# STATEMENT OF ENVIRONMENTAL EFFECTS

S4.56 APPLICATION IN RELATION TO  
APPROVED SHOPTOP HOUSING  
DEVELOPMENT

1 BILAMBEE AVENUE, BILGOLA PLATEAU

**Figure 3:**  
**Proposed**  
**modification –**  
**Basement 1**

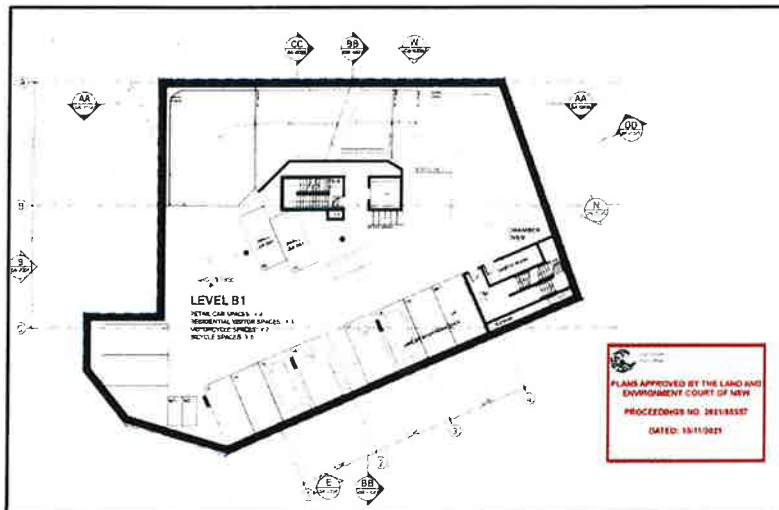
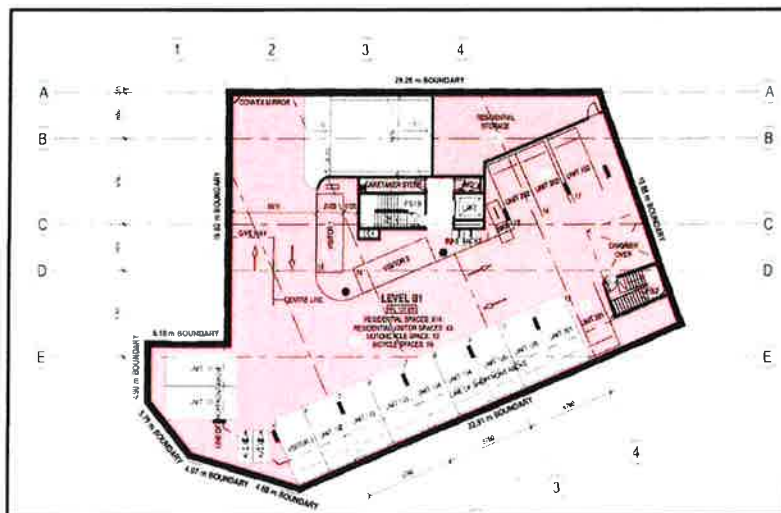
| Proposed Modifications |   |
|------------------------|---|
| <b>Basement 1</b>      |   |
| 01                     | Removal of Basement 2 level   |
| 02                     | Residential storage relocated to basement 1   |
| 03                     | Addition of caretaker facilities, including storeroom and WC                          |
| 04                     | Additional parking added to Basement 1 (similar configuration as previous Basement 2) |
| 05                     | Fire stairs (FS2) reconfigured  |

**Figure 5:**  
Proposed  
modification –  
Ground Floor  
Level

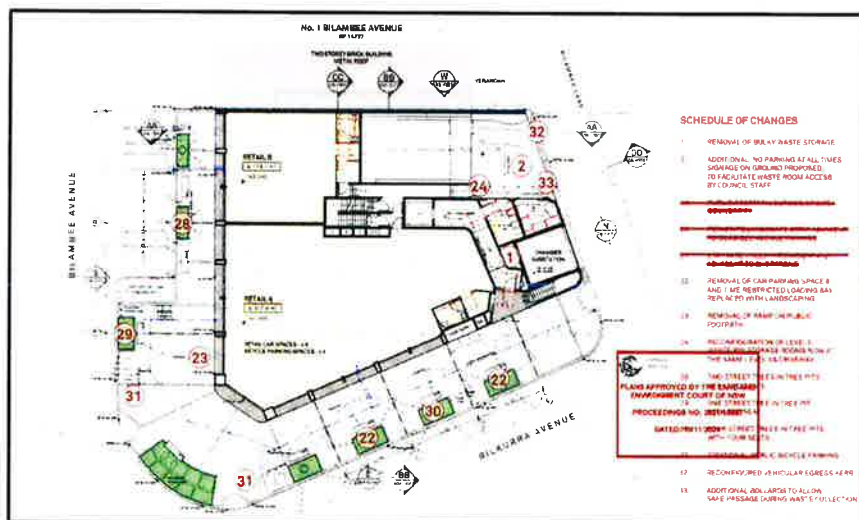
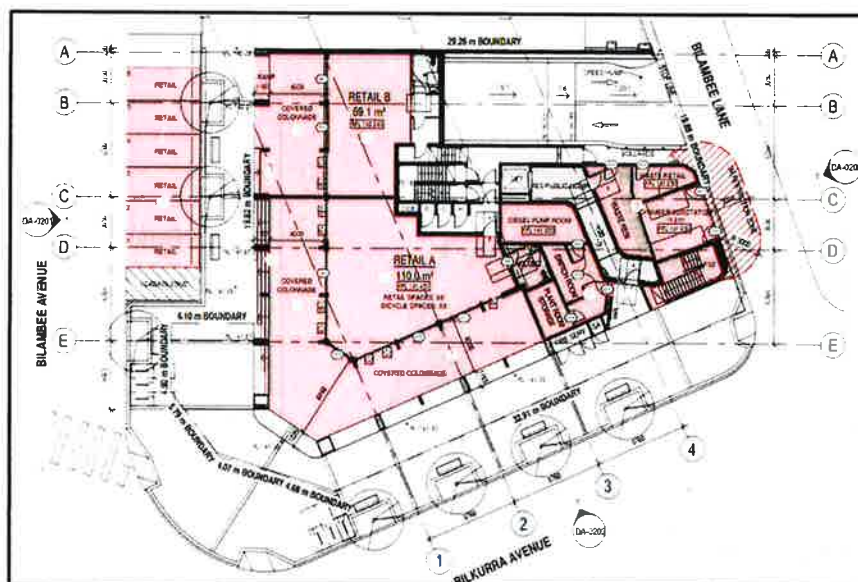
| No. | Proposed Modifications  |
|-----|---|
|     | <b>Ground Floor</b>   |
| 01  | Retail area reduced   |
| 02  | External walls pushed back to create covered colonnade space in front of retail areas                           |
| 03  | Steps from pedestrian pathway to colonnade/retail areas   |
| 04  | Six retail on street parking spaces   |
| 05  | Mechanical and electrical service rooms relocated to the ground floor diesel pump room, switch room, plant room |
| 06  | Substation and waste rooms reconfigured to allow for fire stair layout change (FS2)                             |

Figure 7:  
Proposed  
modification  
– Level 1

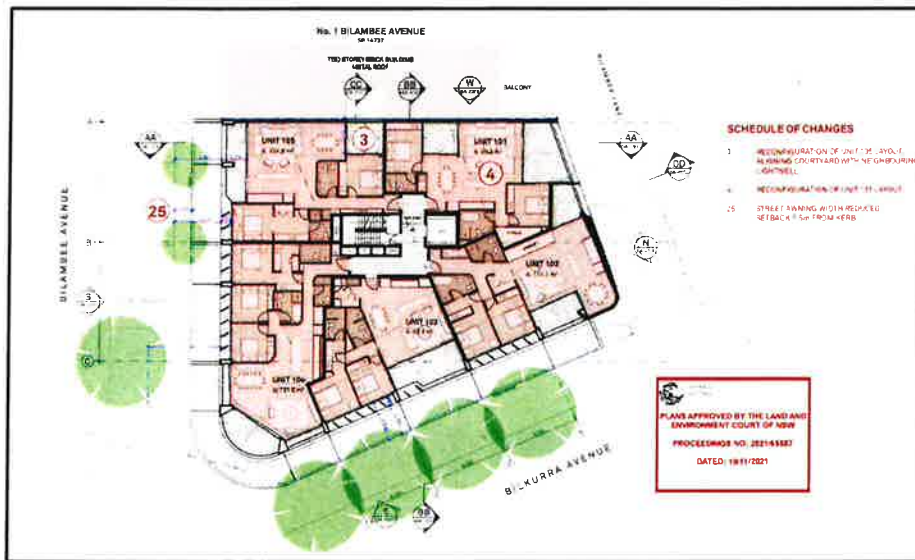
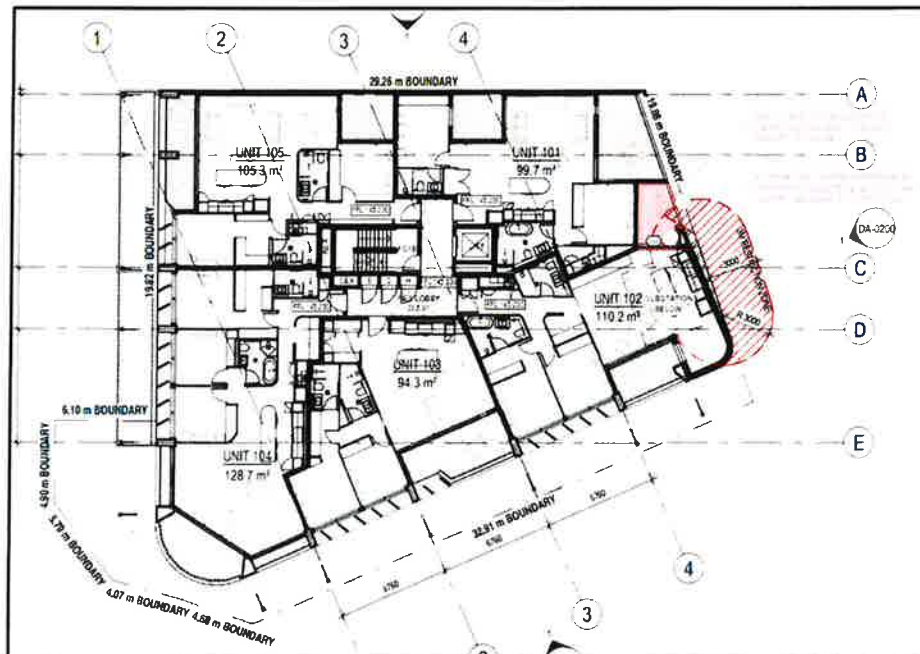
| No.            | Proposed Modifications   |
|----------------|--|
| <b>Level 1</b> |  |
| 01             | Unit 2 balcony external wall for setback to allow for protection from substation. External wall within substation 3m restriction zone to be solid (no gaps) and FRL 180/180/180 to screen D108 |
| 02             | Unit 2 balcony balustrade within substation 3m restriction zone changed to be solid and FRL 180/180/180  |

**Figure 8: Proposed North Elevation**

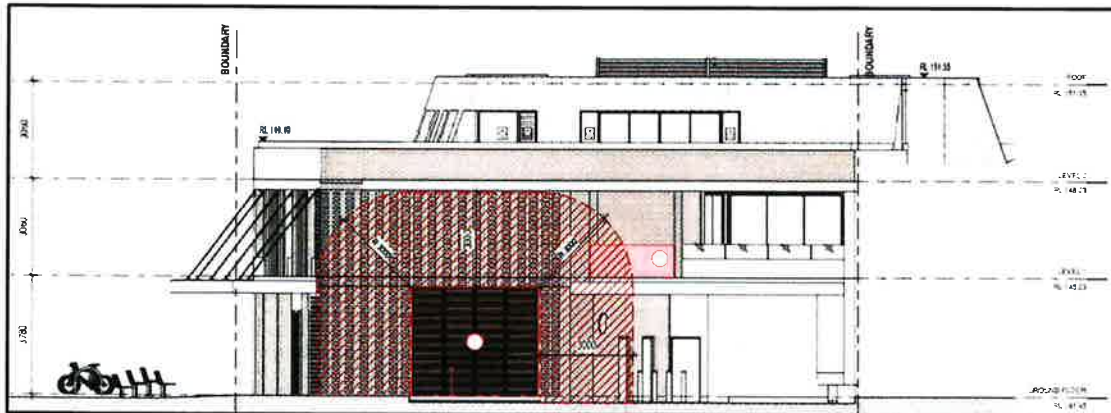
| No. Proposed Modifications – Elevations |   |
|---|---|
|   | <b>North Elevation</b>  |
| 01                                      | Substation moved west to allow for fire stair changes   |
| 02                                      | Unit 2 balcony balustrade within substation 3m restriction zone changed to be solid and FRL 180/180/180 |

**Figure 9: Proposed South Elevation**

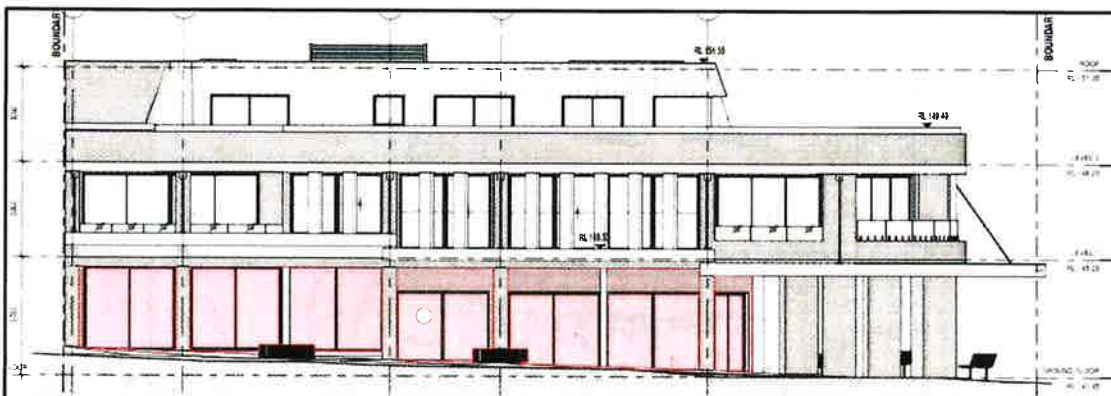
| No. Proposed Modifications – Elevations |   |
|---|---|
|   | <b>South Elevation</b>  |
| 01                                      | External walls pushed back to create covered colonnade space in front of retail areas |

**Figure 10: Proposed East Elevation**

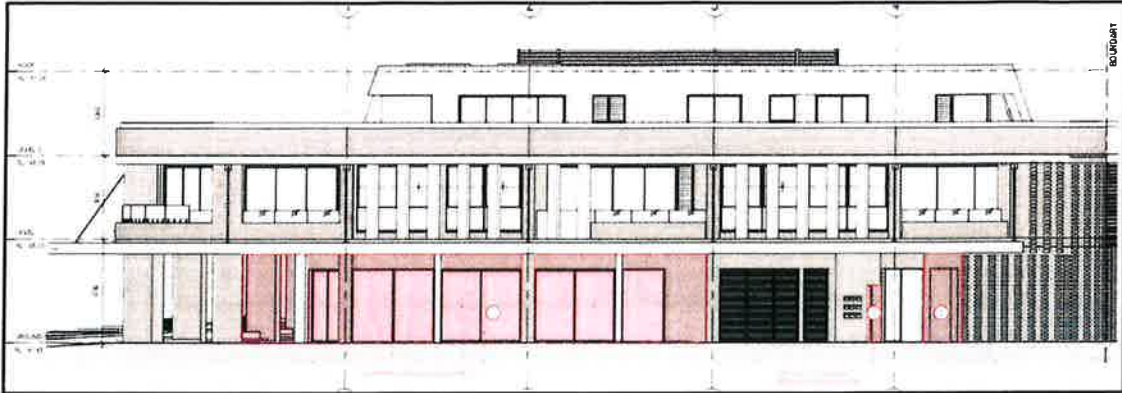
| No. Proposed Modifications – Elevations |   |
|---|---|
| <b>East Elevation</b>                   |   |
| 01                                      | External walls pushed back to create covered colonnade space in front of retail areas |
| 02                                      | New door to mechanical and electrical service rooms relocated to the ground floor     |
| 03                                      | Amended fire stair (FS2) layout and new exit from fire exit                           |

**Figure 11: Proposed West Elevation**

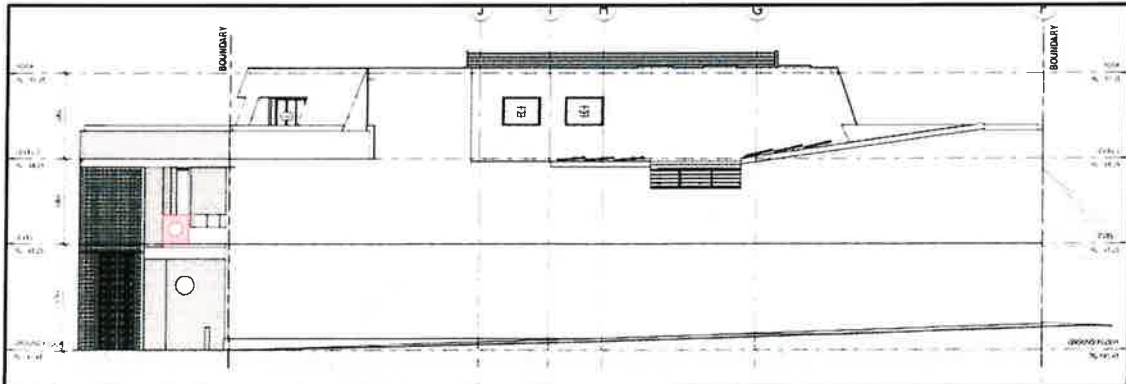
| No. Proposed Modifications – Elevations |   |
|---|---|
| <b>West Elevation</b>                   |   |
| 01                                      | Unit 2 balcony balustrade within substation 3m restriction zone changed to be solid and FRL 180/180/180 |
